ADDENDUM NO. 1

April 14, 2022

YOST ELEMENTARY SCHOOL ADDITIONS AND RENOVATIONS Chesterton, IN 46304

Addendum One (AD.01) to the drawings and specifications prepared by Gibraltar Design for **New Yost Elementary School** for Duneland School Corporation, Chesterton, Indiana.

MP103

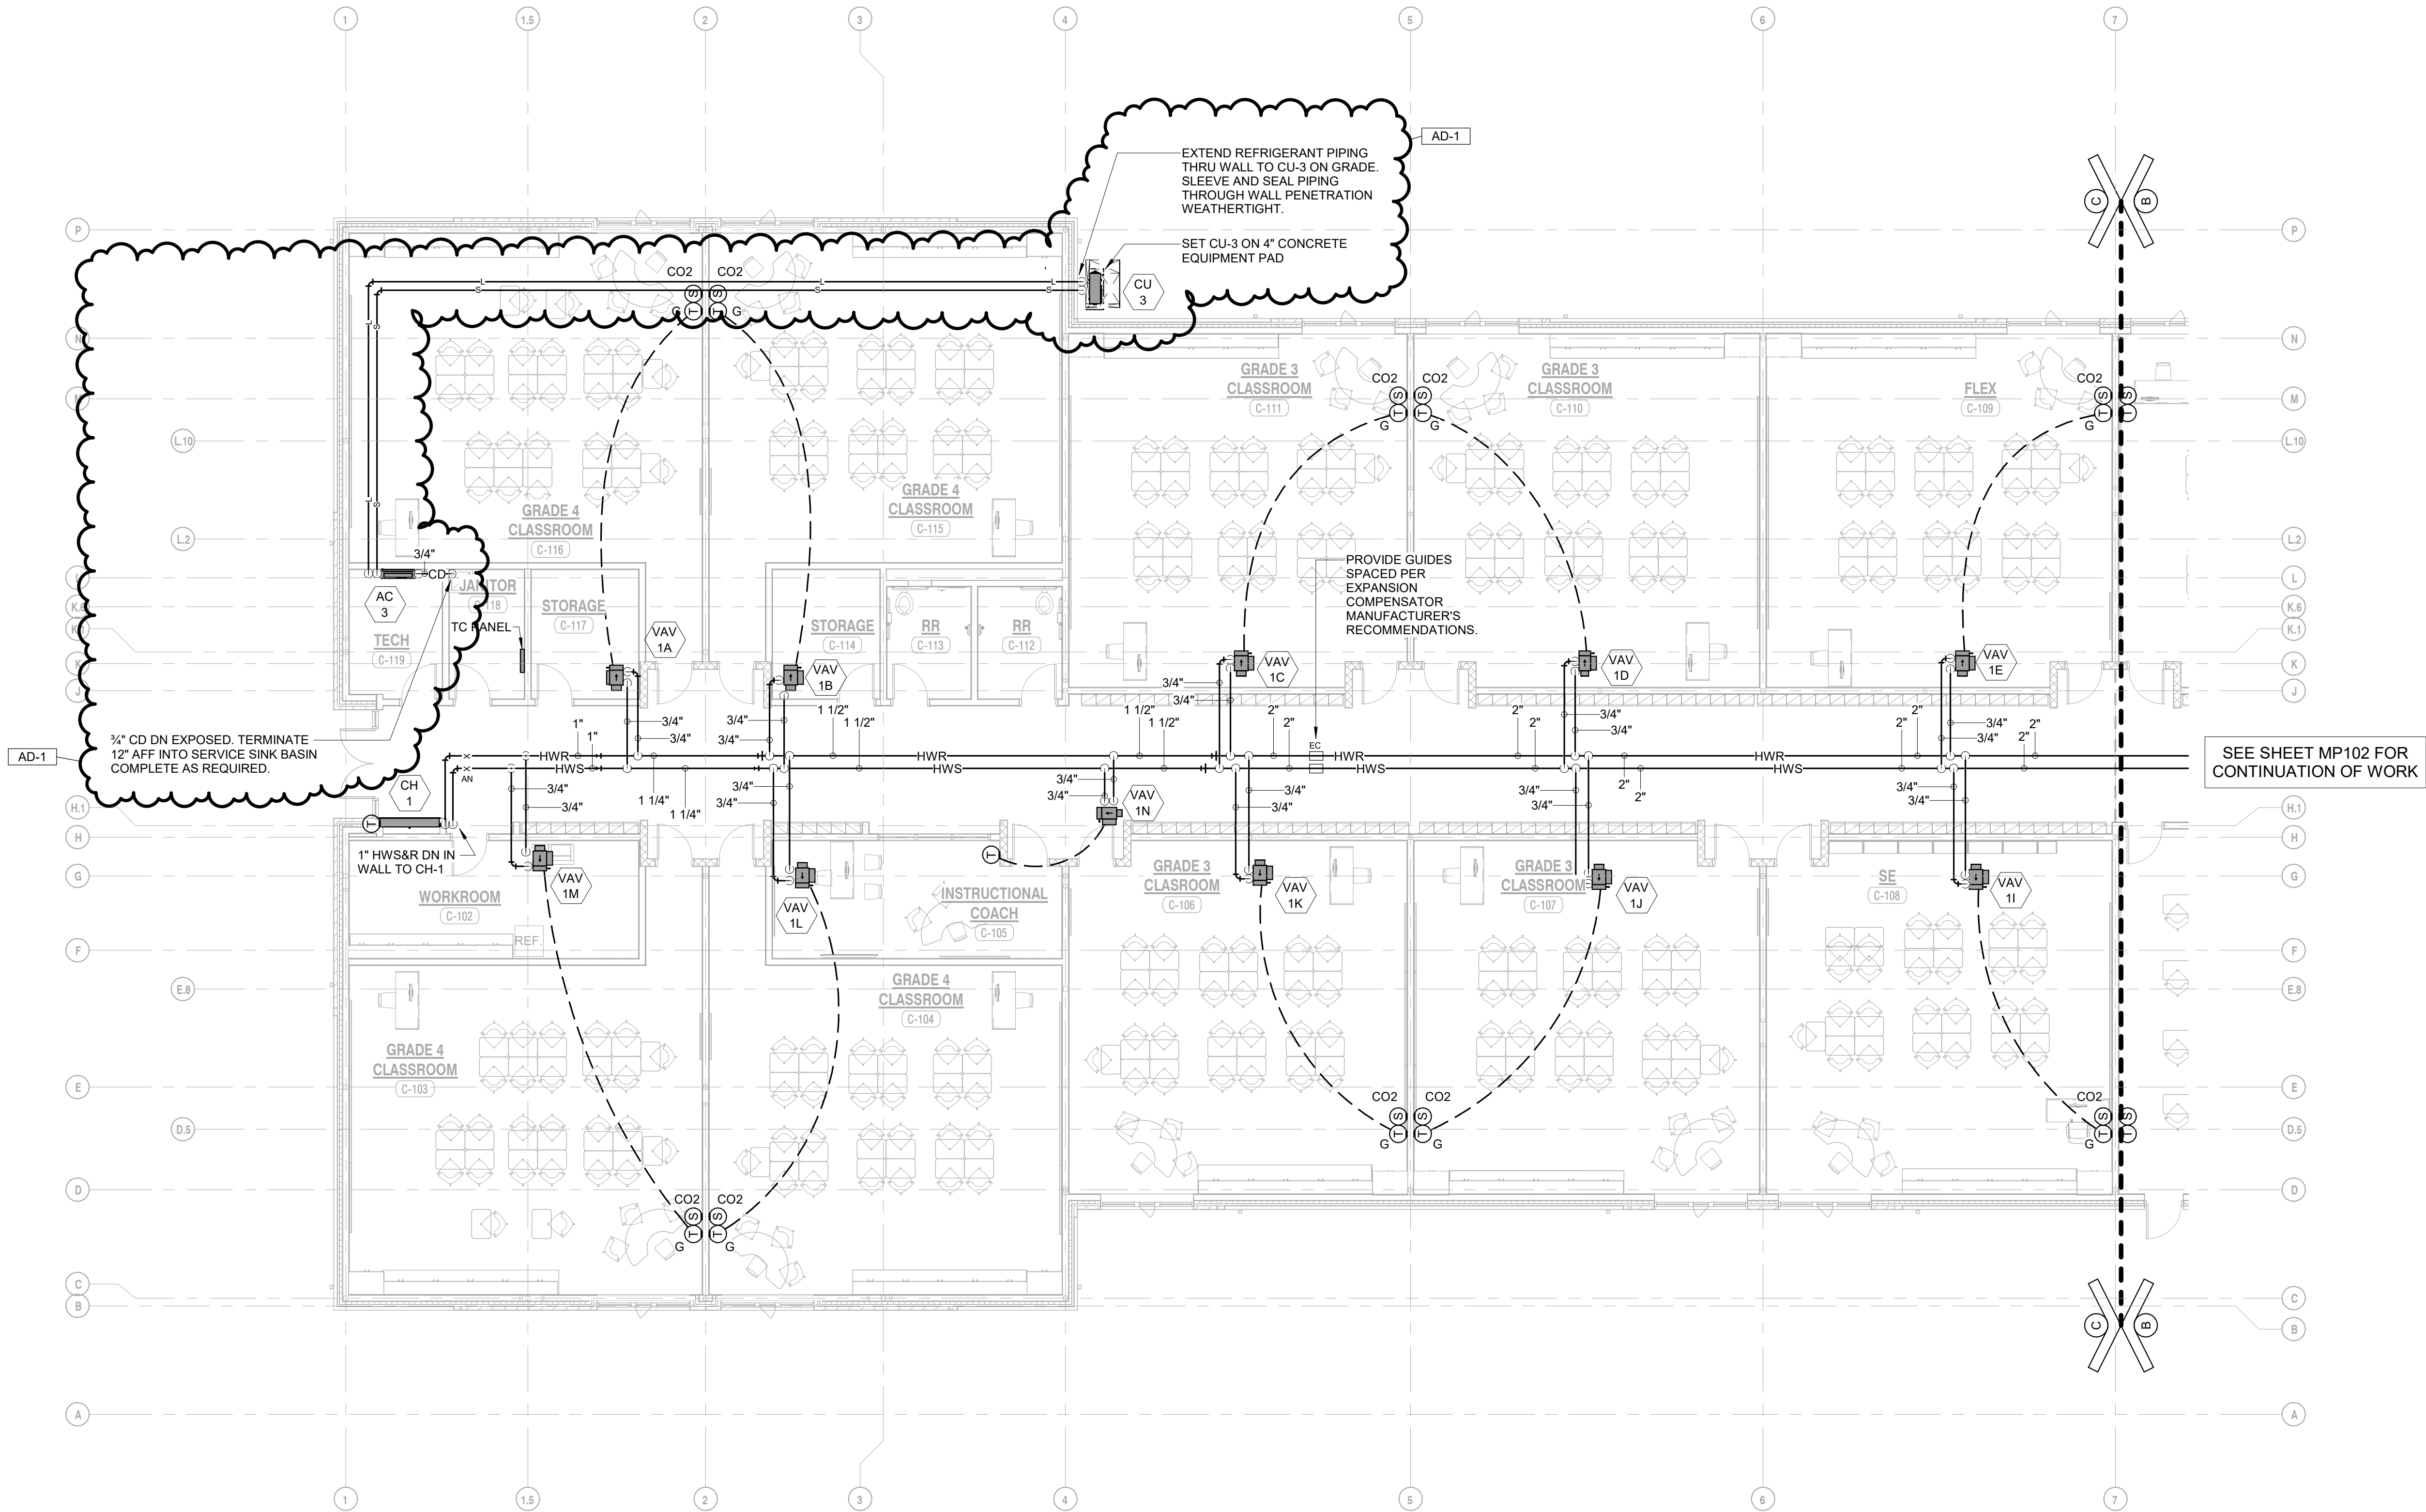
34. Sheet MP103

- A. Refer to revised full size drawing, included in this Addendum, for the following revisions:
 1. Relocated CU-3 to north side of building and rerouted associated refrigerant piping.
 2. Revised condensate piping to terminate in Janitor C-118.

GIBRALTAR
DESIGN
E
SHEET
MP105

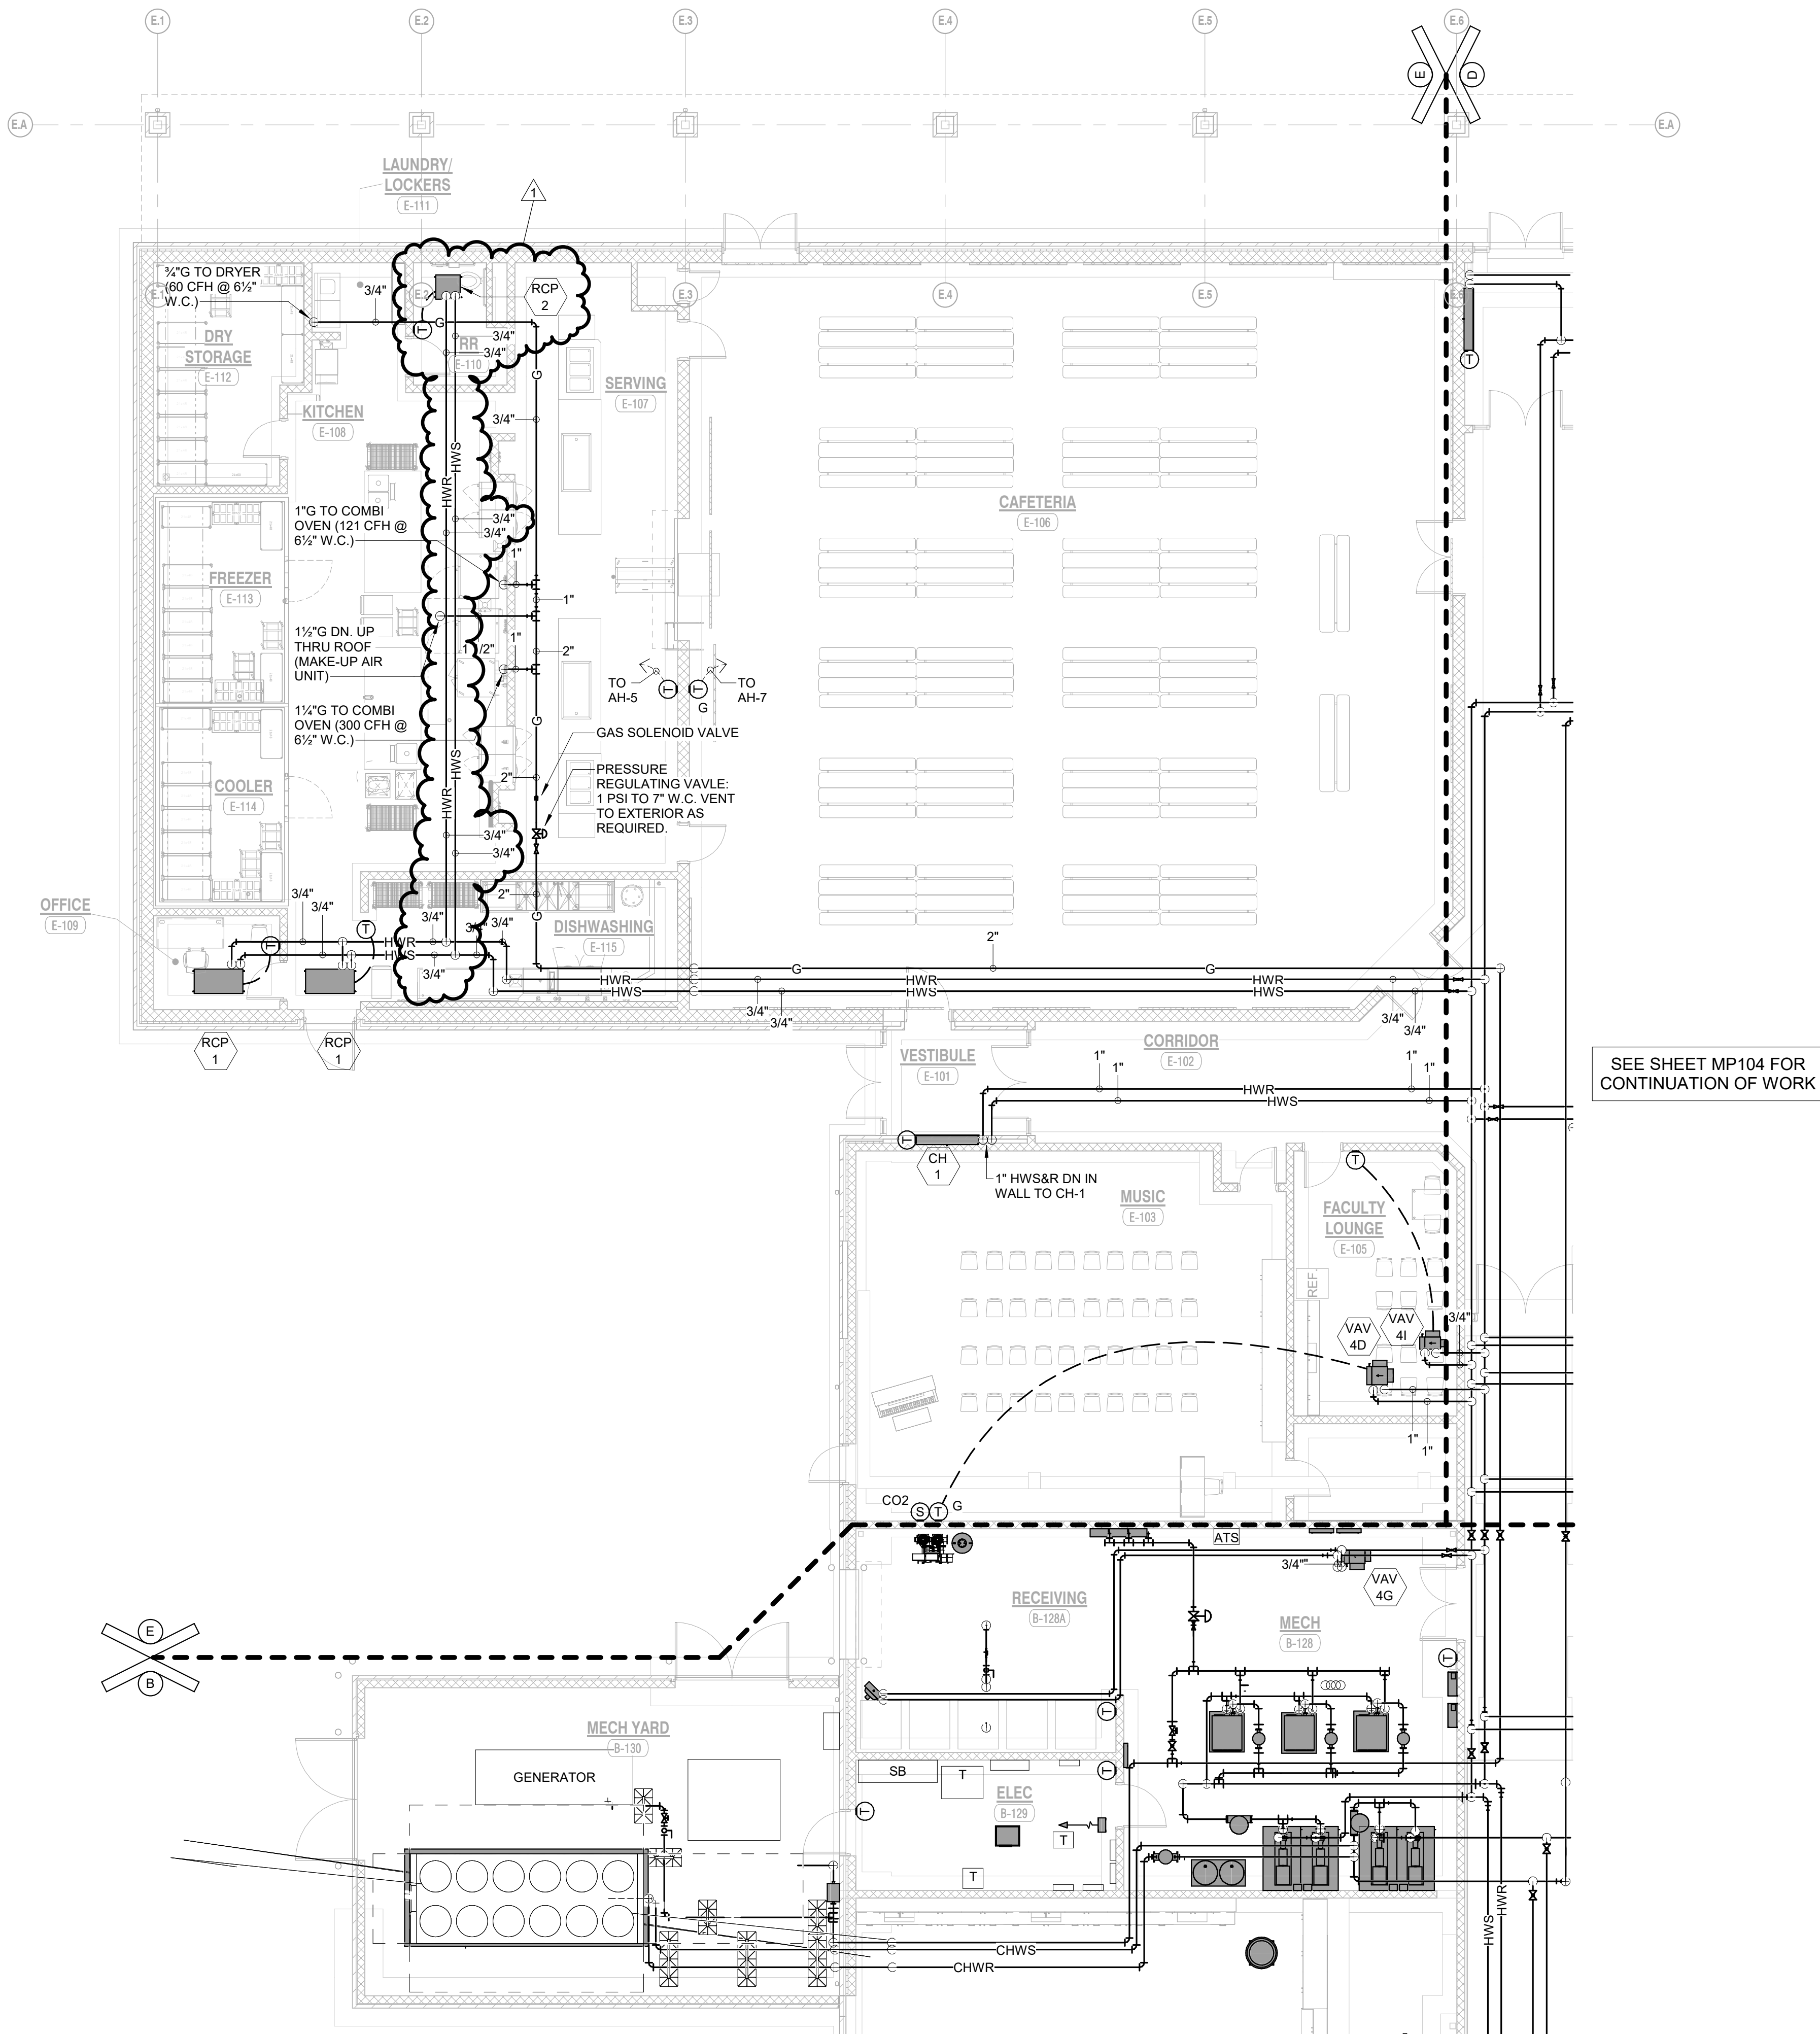
35. Sheet MP105

- A. Refer to revised full size drawing, included in this Addendum, for the following revisions:
 1. Added radiant ceiling panel (RCP-2) and associated thermostat to RR E-110.

INCOMING DOMESTIC WATER SERVICE DIAGRAM

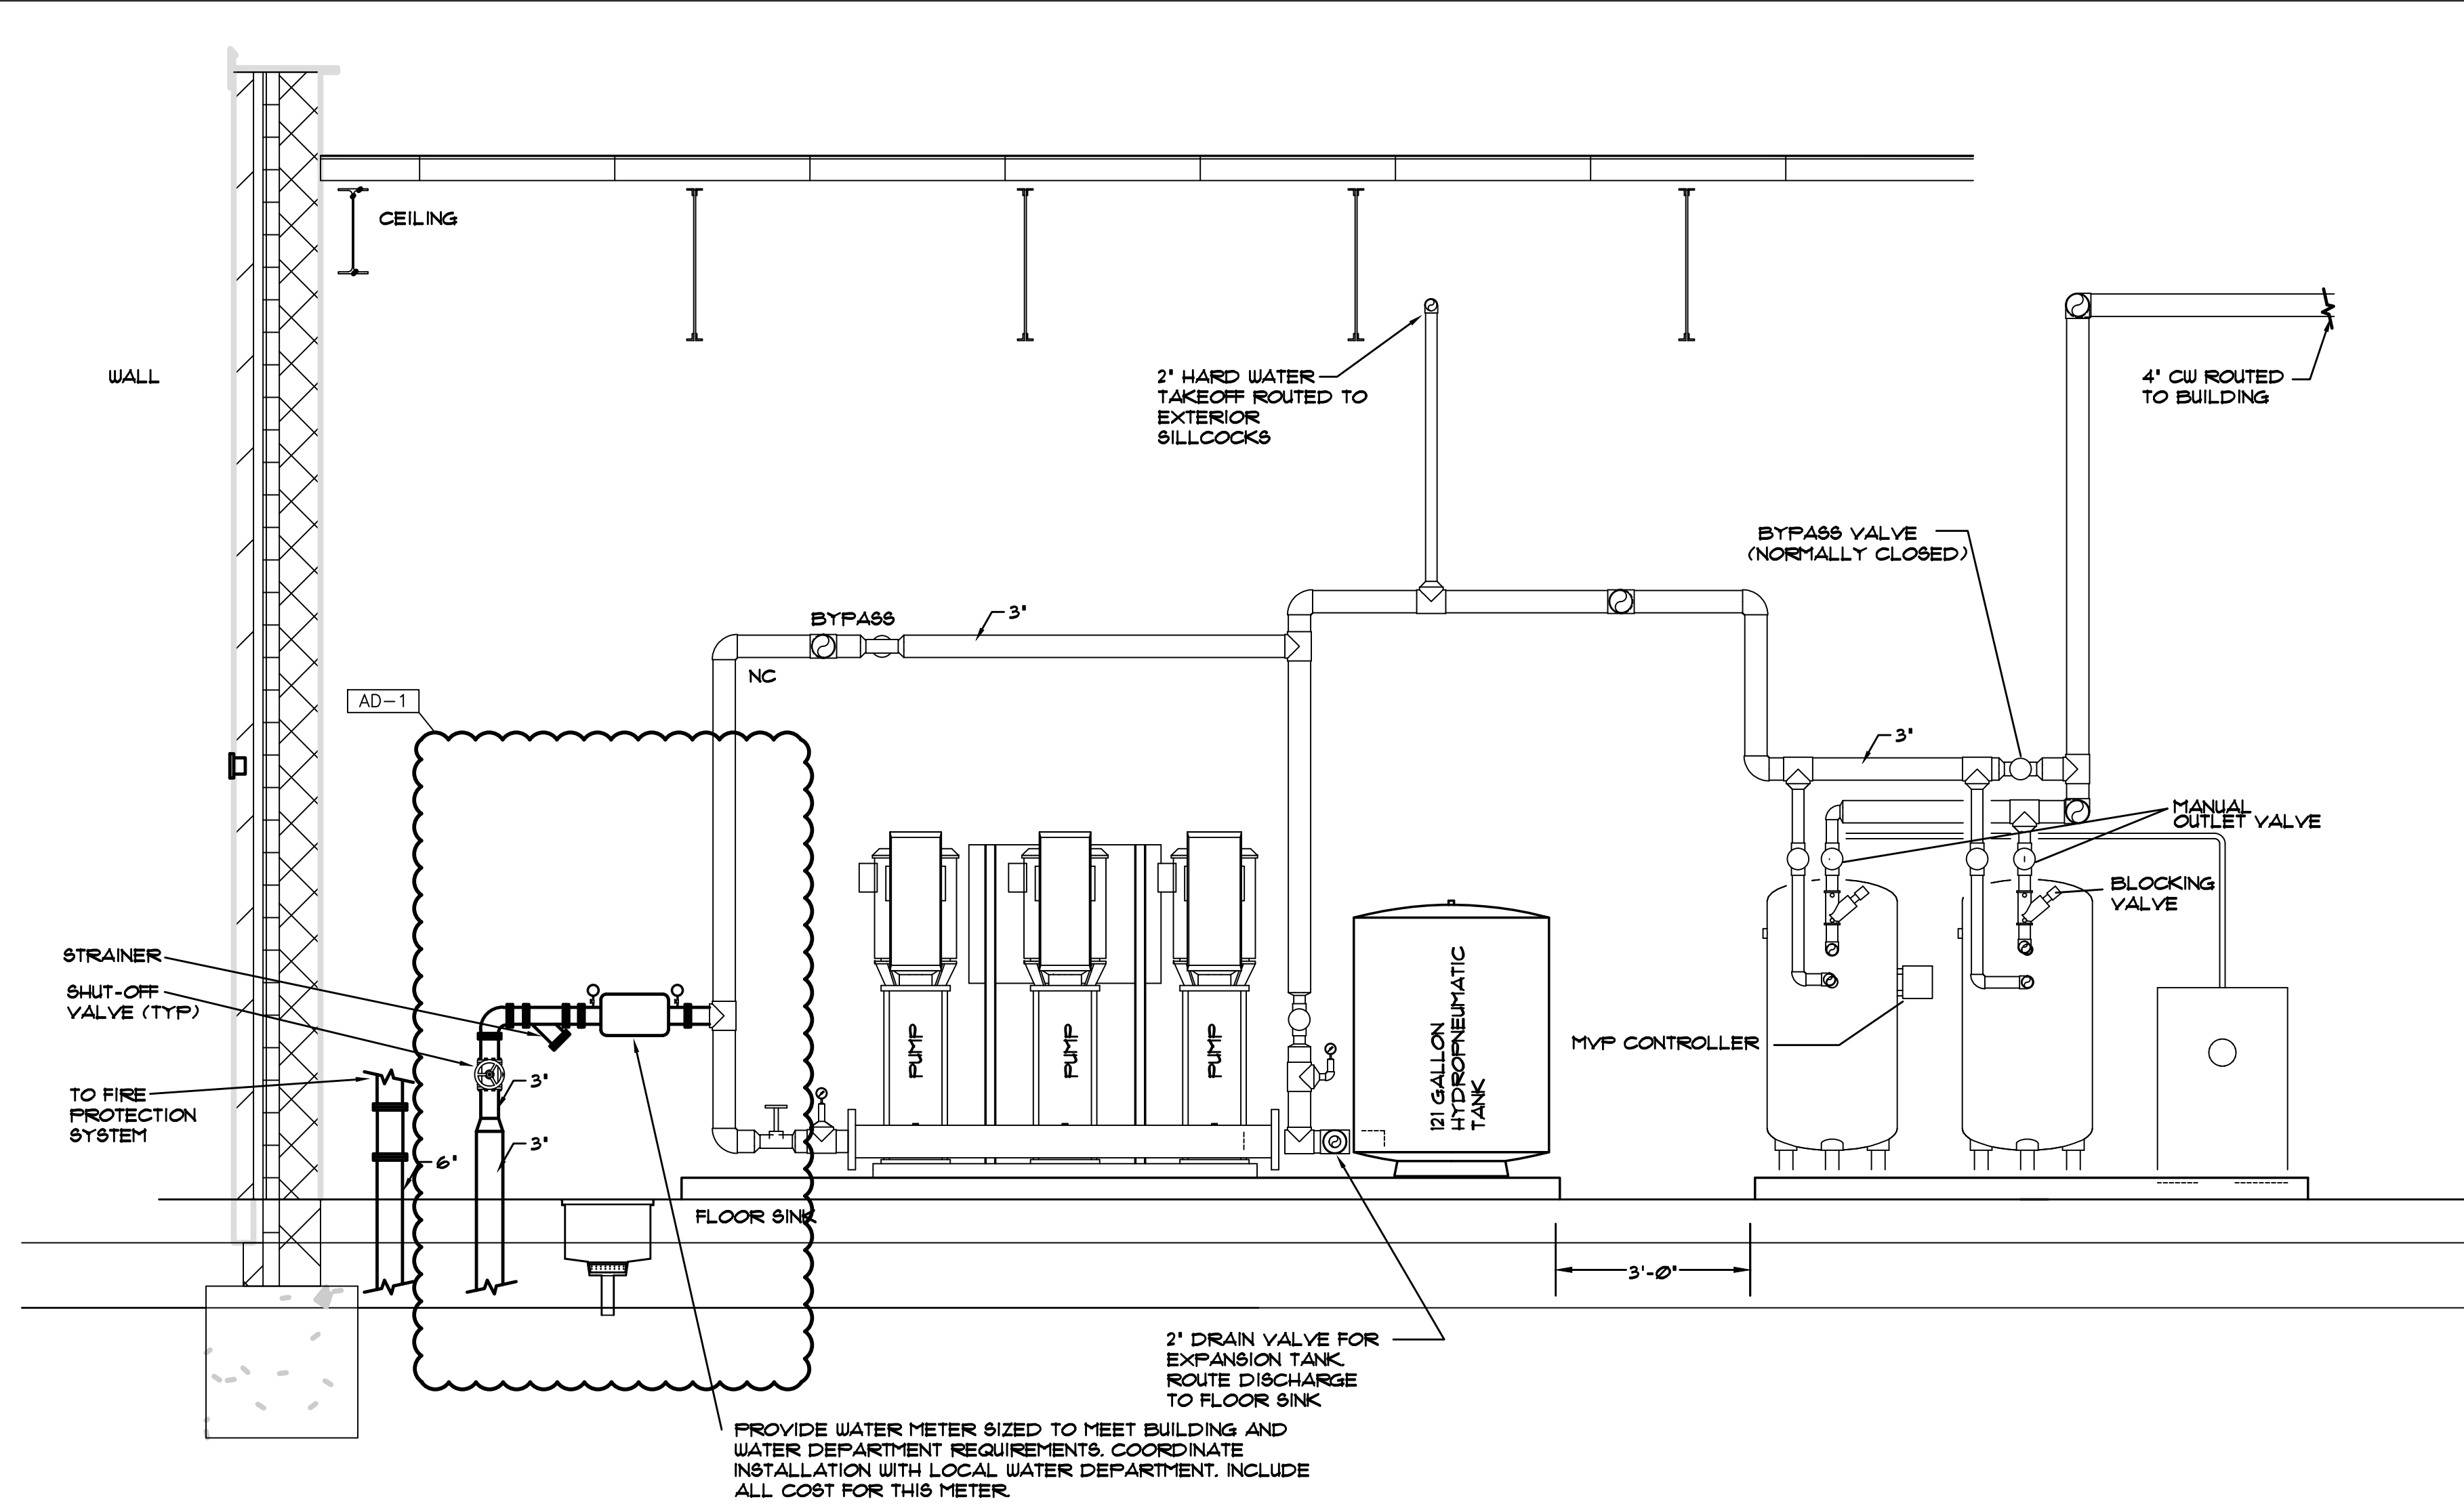
42. Sheet P-601

- A. Refer to revised full size drawing, included in this Addendum, for revised incoming domestic water service diagram.
